HISTORIC AND DESIGN REVIEW COMMISSION

HDRC CASE NO: 2017-308
ADDRESS: 130 W LULLWOOD AVE
LEGAL DESCRIPTION: NCB 6534 BLK 14 LOT 87 THRU 90
ZONING: R-5 H
CITY COUNCIL DIST.: 1
DISTRICT: Monte Vista Historic District
APPLICANT: David Morales/Helotes Builders
OWNER: Javelina Properties
TYPE OF WORK: Garage door replacement
REQUEST:

The applicant is requesting a Certificate of Appropriateness for approval to replace two existing wood carriage garage doors with a single overhead metal garage door.

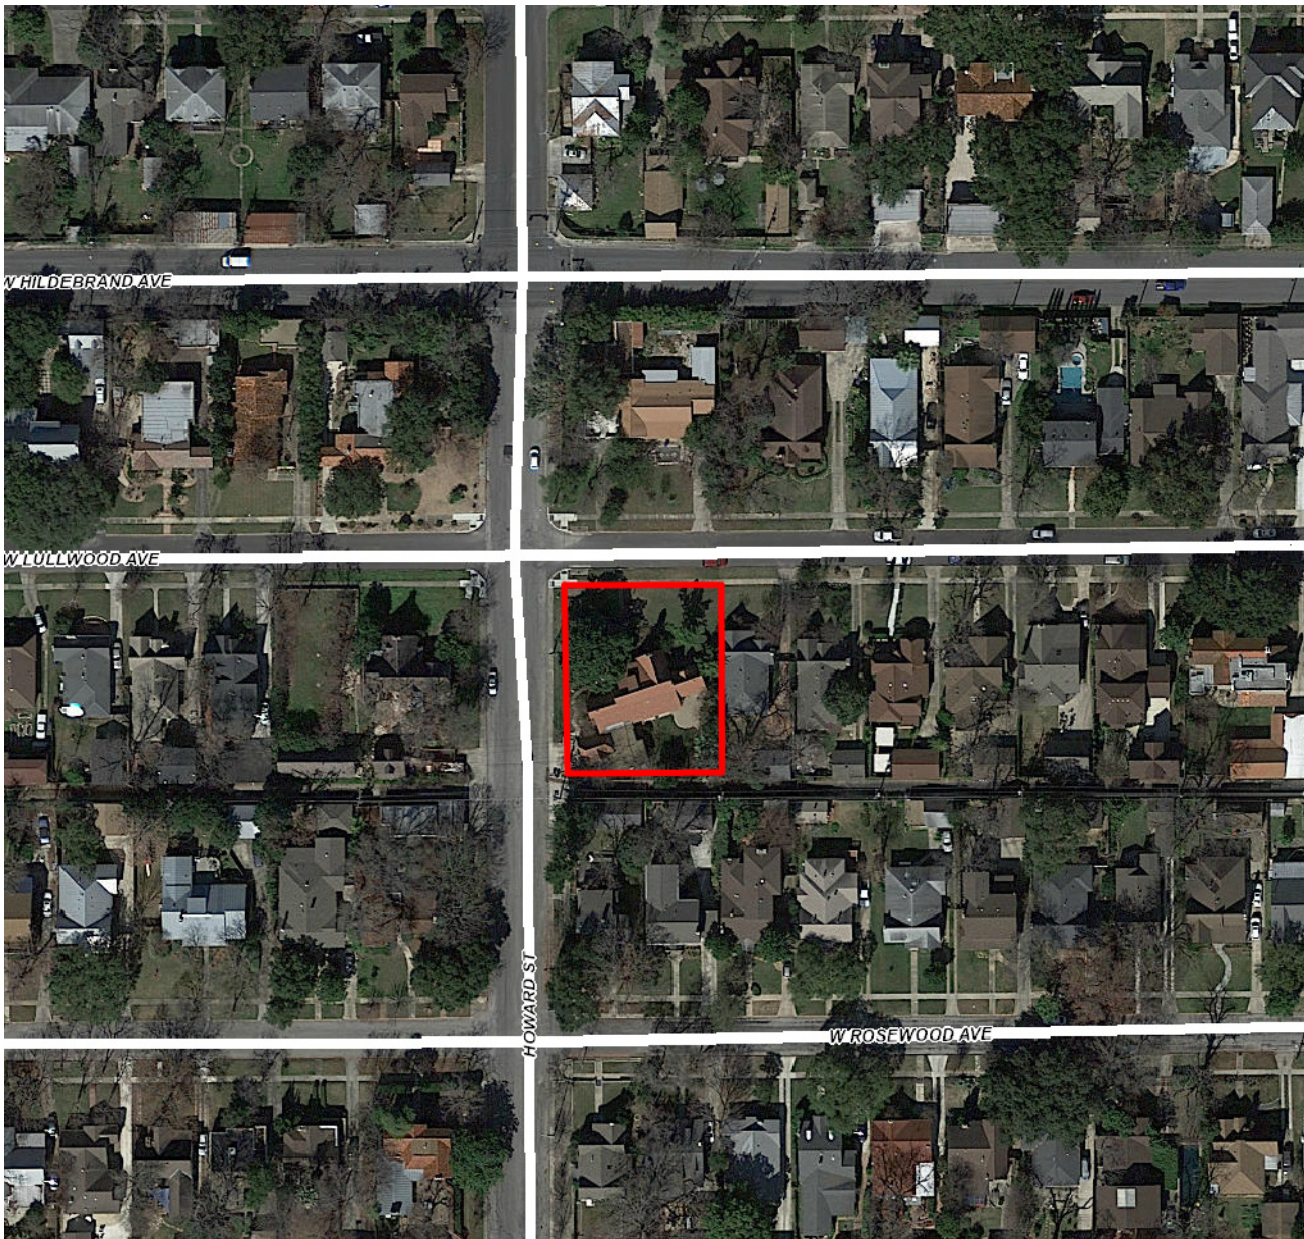
- a. The primary structure located at 130 W Lullwood Ave is a single family home constructed in 1929 in the Tudor style. The home features several elements reflective of the Tudor style, including a massive chimney with decorative chimney pots, steeply pitched roof, and decorative half-timbering. The house was designed by architect Robert McGarraugh, who was prolific along the Lullwood corridor. The home is a contributing structure in the Monte Vista Historic District. The property is located on a corner lot and contains a rear accessory structure facing Howard St, also designed in the Tudor style. The rear accessory structure is contributing to the Monte Vista Historic District. The applicant is proposing to replace two wood carriage garage doors with a single

overhead metal garage door on the rear accessory structure.

- b. According to Guideline 9.B.i, replacement garage doors should be compatible with the primary structure, as well as those found on historic garages in the district. When not visible from the public right-of-way, modern paneled garage doors may be considered. Because of the property's corner lot location, the garage is directly visible from the public right-of-way and engages the Howard St streetscape. The proposed single overhead metal garage features traditional decorative elements, but is a change in material and configuration and permanently modifies the historic double door opening. Staff does not find the proposal consistent with the Guidelines.

Staff does not recommend approval based on findings a and b.
